UNITED STATES PATENT AND TRADEMARK OFFICE

APPLICATION NO.	FILING DATE	FIRST NAMED INVENTOR	ATTORNEY DOCKET NO.	CONFIRMATION NO.
09/932,830	08/17/2001	April Marano-Ford	266/098	4525

Office Action Summary

DETAILED ACTION

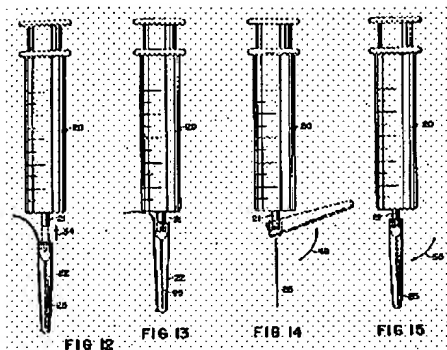
Claim 1 is rejected under 35 U.S.C. 102(b) as being anticipated by **Miller**.

In figures 11-15, the Miller patent shows a cover including an elongate channel and a retainer engageable with the needle assembly with the elongate channel positioned over the needle, a mount including a socket to rigidly retain the luer hub of the needle assembly, a hinge, the cover being mounted to the mount by the hinge with the elongate channel extending longitudinally from the hinge; a flexible tear strip extending over the channel, enclosing the needle with the channel.

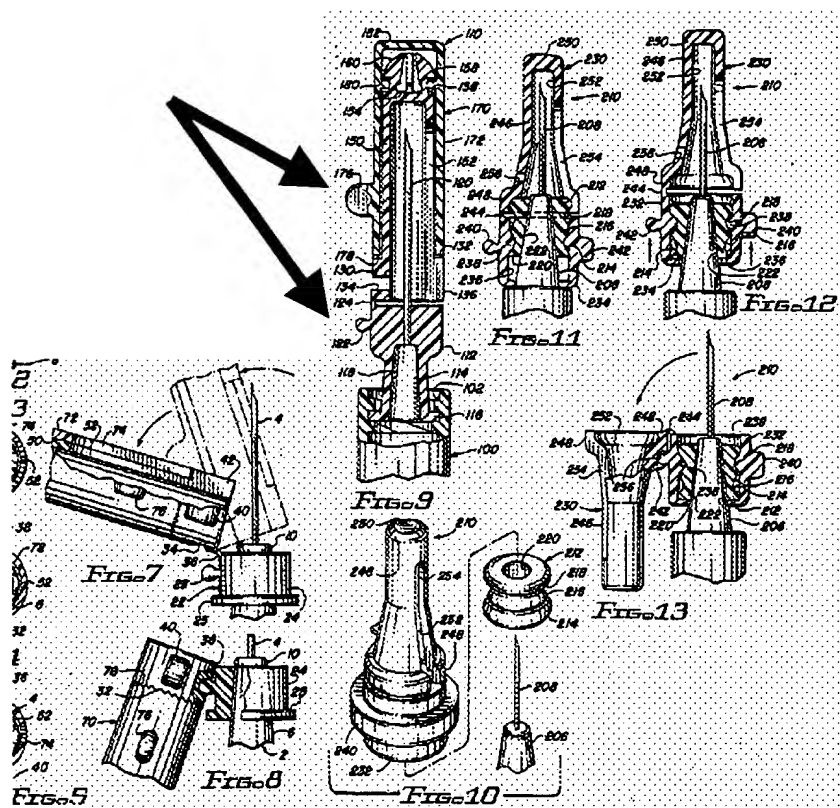
Claims 2-40 are rejected under 35 U.S.C. 103(a) as being unpatentable over **Miller in view of Opalek**. The Miller patent does not disclose a locking web. However, the use of locking webs in syringe safety shields is conventional in the art as evidenced by the Opalek patent.

In figures 7-10, the Opalek patent shows a locking web designed as part of the structure of a safety shield. The inserted arrows point to the main elements of the locking web in one of the various safety shield embodiments shown above. Accordingly, for a person of ordinary skill in the art, modifying the safety shield disclosed by Miller with a locking web as taught by Opalek, would have enhanced the safety capabilities of the apparatus and consequentially, would have been considered an obvious design choice.
